New G-G1 hinge for frameless glass pool fence

As some unexpected issue happened about the old G-G1 hinge, we now developed a new design G-G1 hinge(same Item No.), please see the comparison as below:

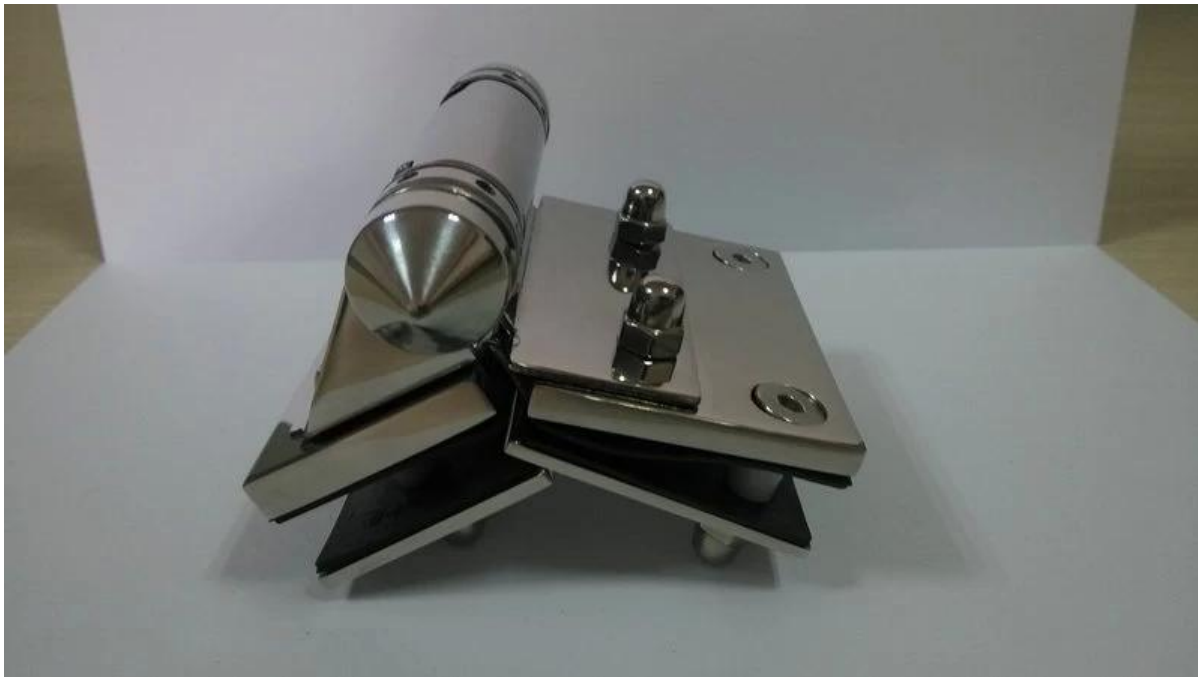
We add two wider pieces of back plate to make the hinge more stronger, but for sure the weight of new G-G1 increased(about double than the old one)

About the material: we still use stainless steel 316L, kept the high quality and ability of anti-rust.
